## LiDAR Quality Assessment Report

### SD\_Missouri-River-Lidar-Dewberry-B2\_2016

NGTOC

2018-06-28

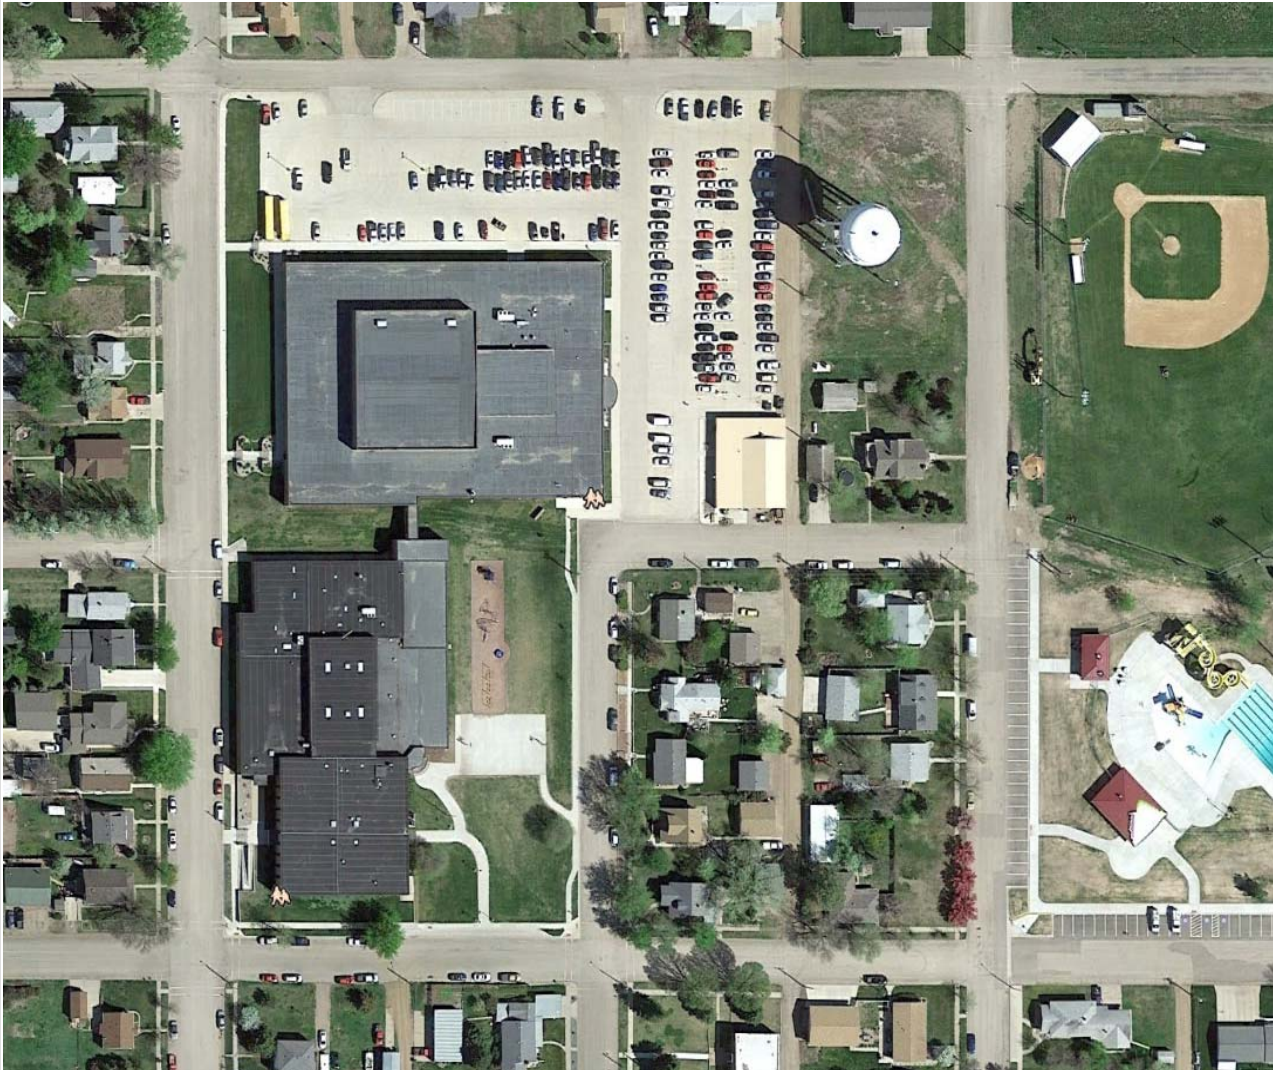
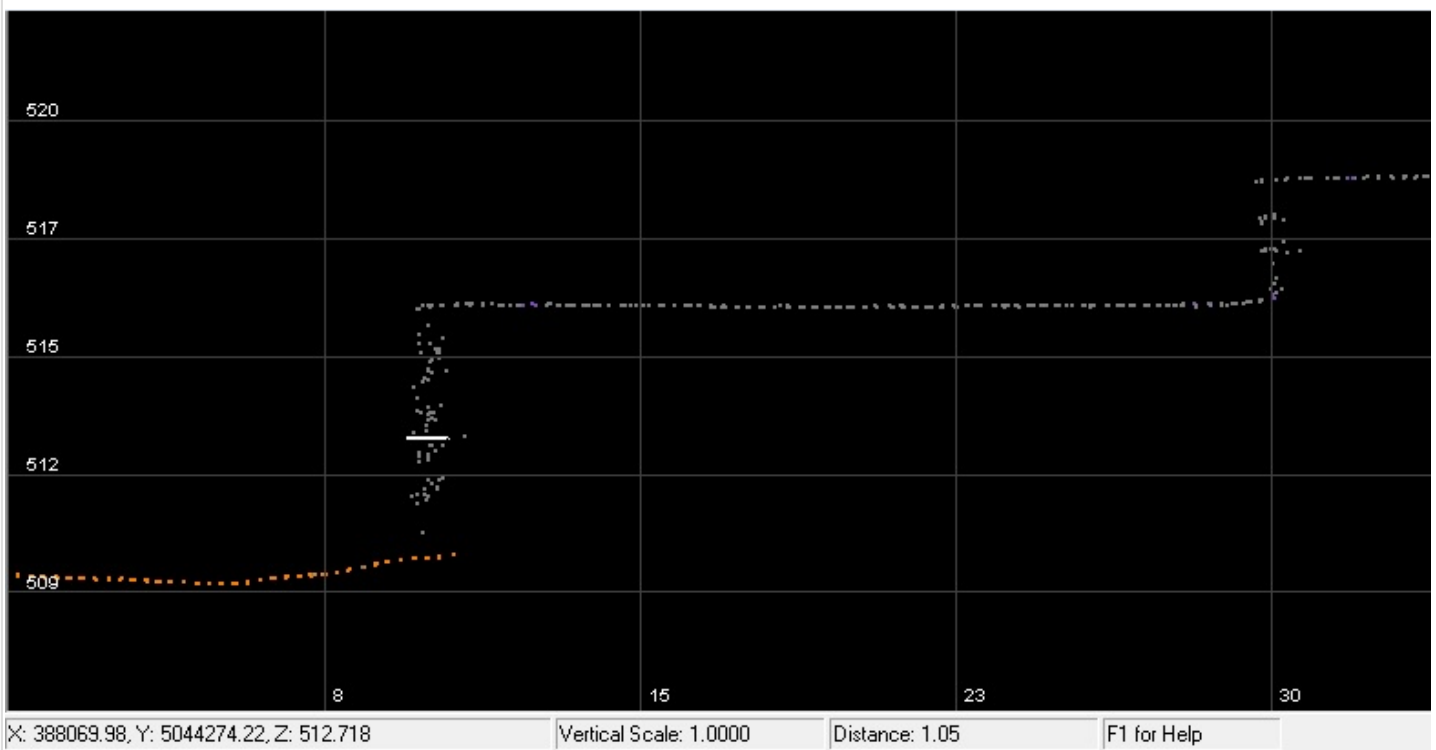
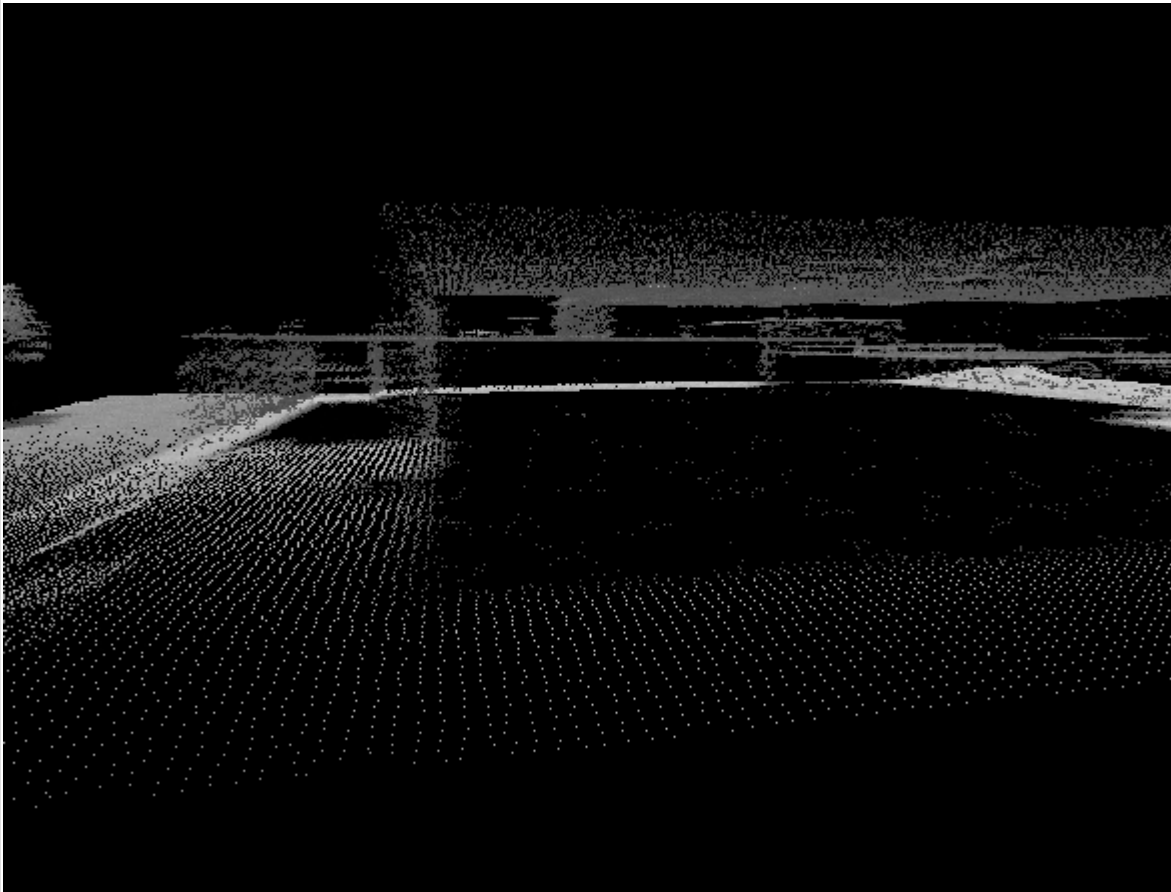
The following images reveal the areal and three-dimensional views, as well as -1meter profile drawn across point cloud representing Mobridge Middle and High School. One hundred percent resolution of the point cloud has been forced.

In this case, the scatter across the wall extends to approximately 1-meter length.

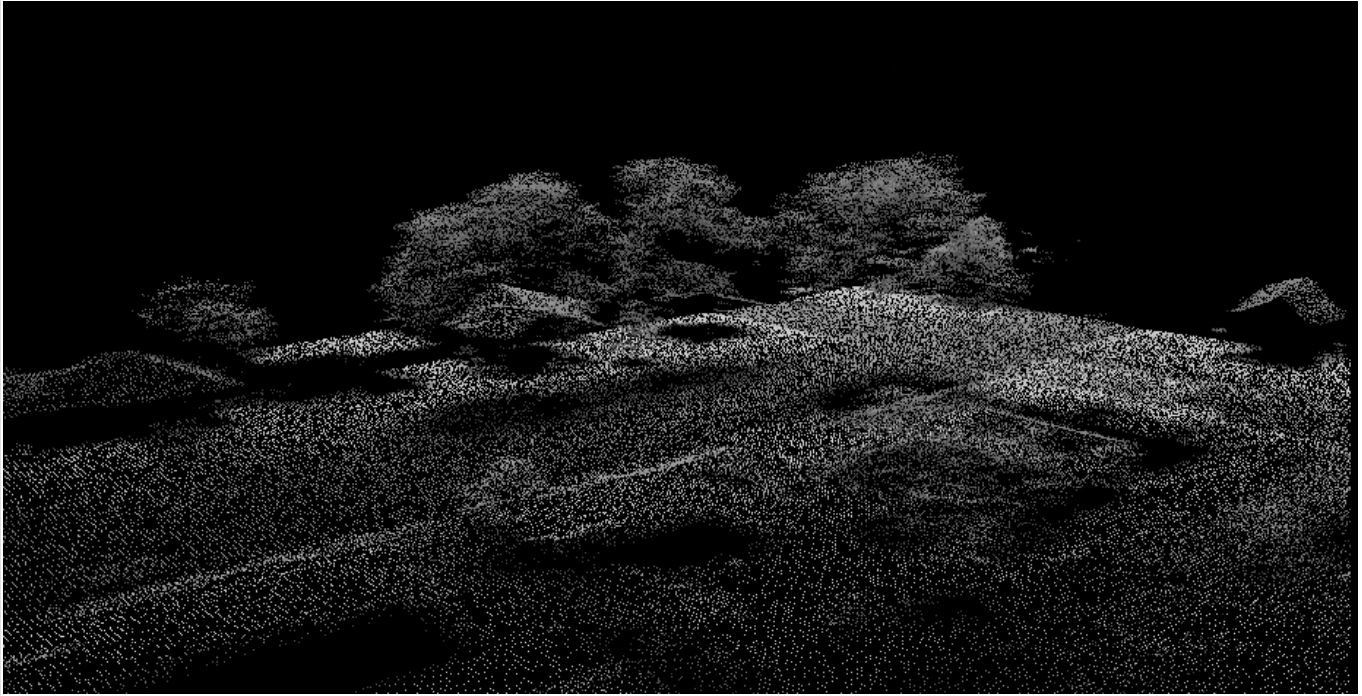
The image below shows three-dimensional view of a residential area. In this case, elevation of the roads appears to be correct, located slightly below the lawns. Trunks of the trees are not visible. In this view, one hundred percent resolution has been forced. The task order stipulated that only 8 points per square meter needed to be supplied.

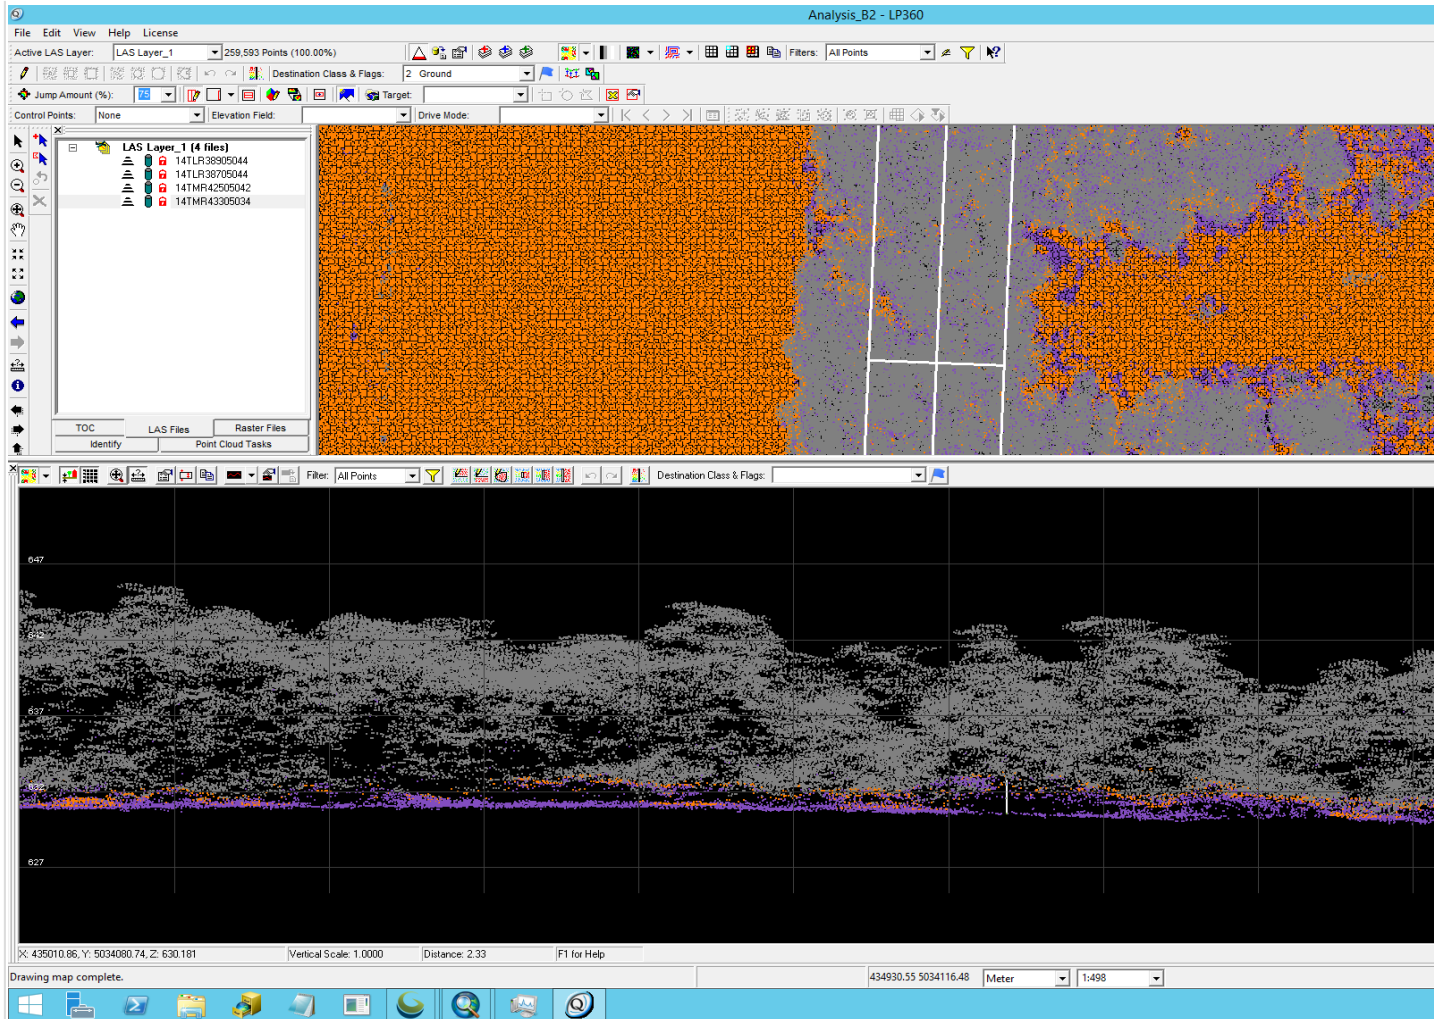
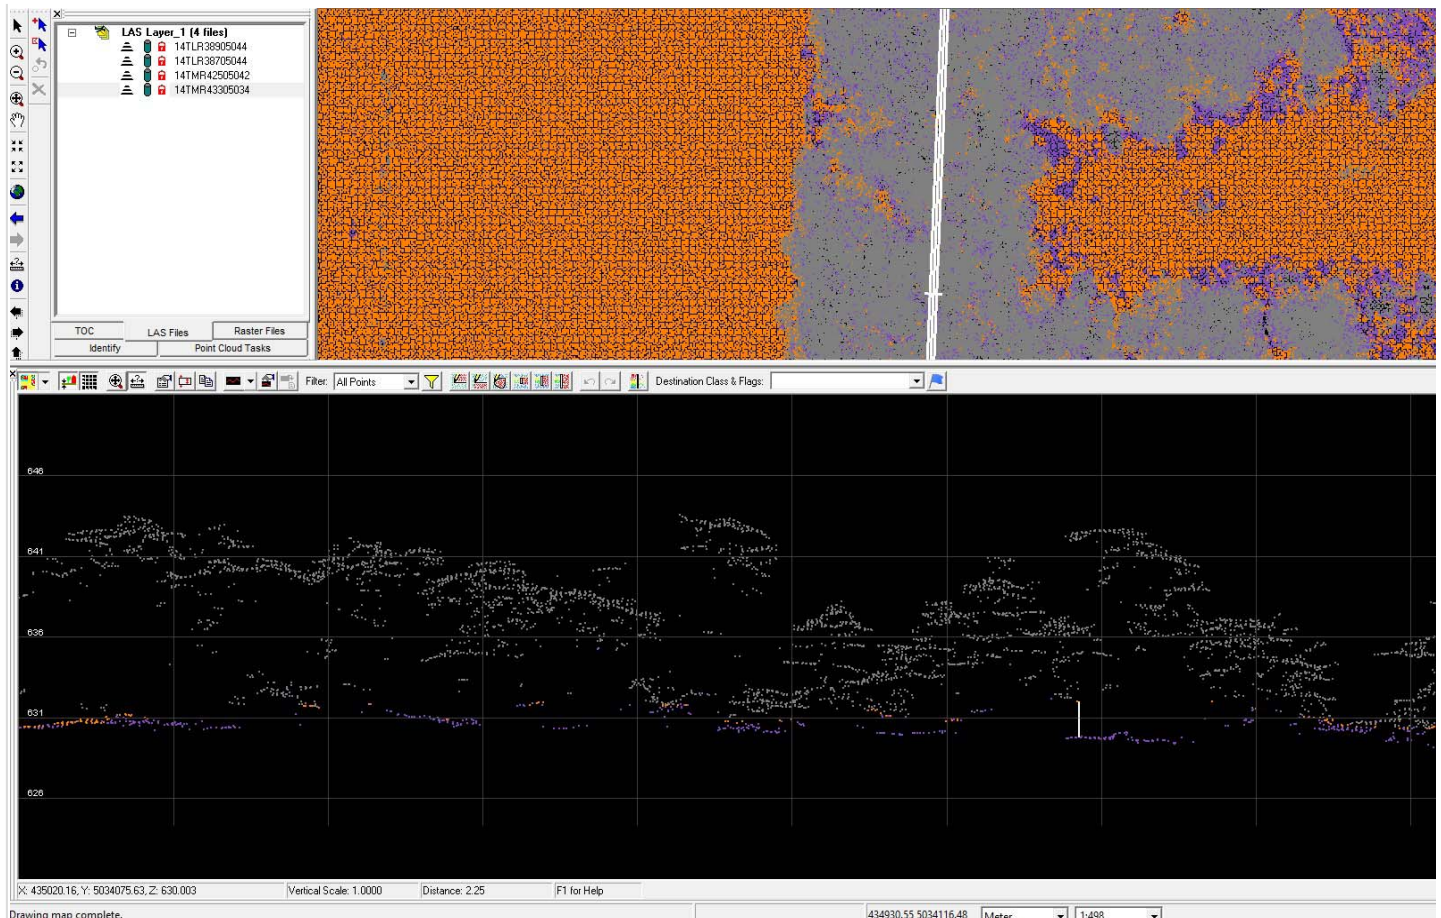
5) The following image exemplifies a tree line profile. Vegetation is classified as and portrayed in gray color, ground points are displayed in orange color, and noise points are identified in purple color. The first profile (a) has depth of twenty meters and the second contour (b) has one meter depth.

The measurement of the lower section, indicating the distance between the lowest noise points and highest ground points is approximately three meters. Tree trunks could not be distinguished among the canopy cover.

In the instance of the one meter profile, the measurement of the lower section, indicating the distance between the lowest noise points and highest ground points is approximately two and a half meters. The profile reveals sparse ground cover, suggesting relatively poor canopy penetration.

Still, possibly some of the points could be re-assigned from the noise to the ground category. This draws attention to probable difficulties associated with automatic post processing of the data derived from the Geiger-mode sensor.

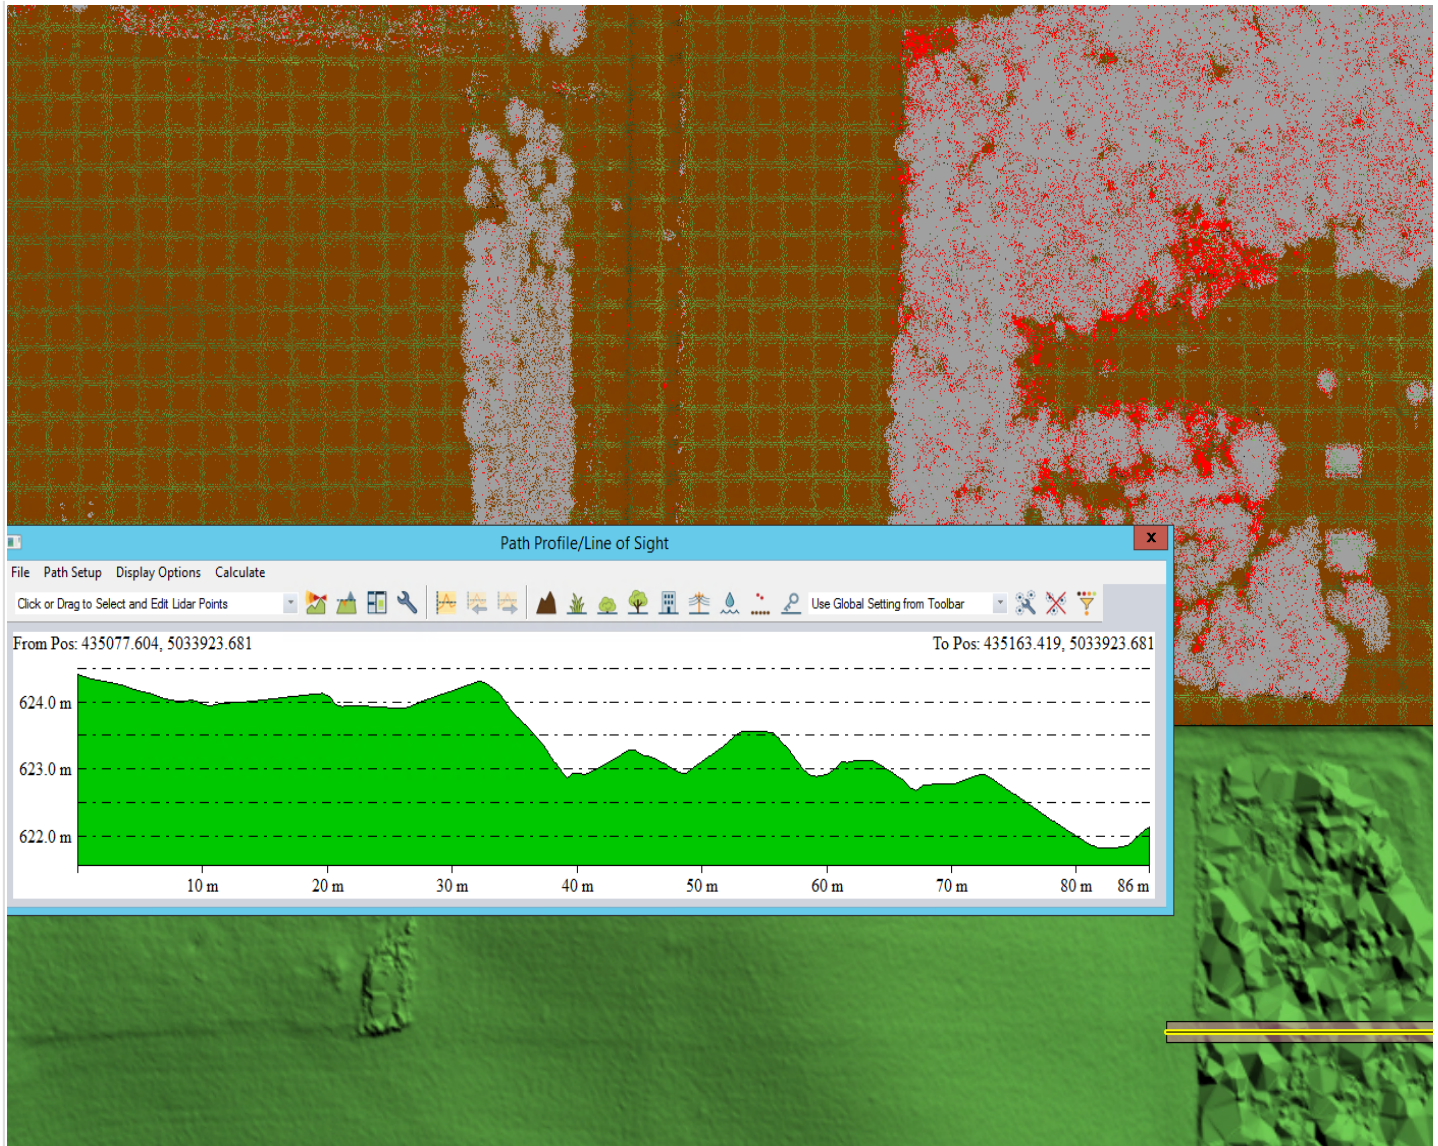
A discernable pattern emerges when looking at the data at different scales and in both Global Mapper and LP360 software. In earlier discussions, Dewberry provided an explanation that the grid line pattern was generated by software rather than a remnant from the algorithm used to process the point cloud. The two screen captures above were taken at the scale of 1:498 meters. The image below shows the same area in Global Mapper at the scale of 1:1096 meters. The top part of the digital elevation model (DEM) is overlaid with the point cloud data. In the case of Global Mapper display, the one hundred percent resolution of the point cloud was not forced.

The bottom of the image reveals a tinned ground in the part of the DEM generated in the area where a strip of tree line was present.
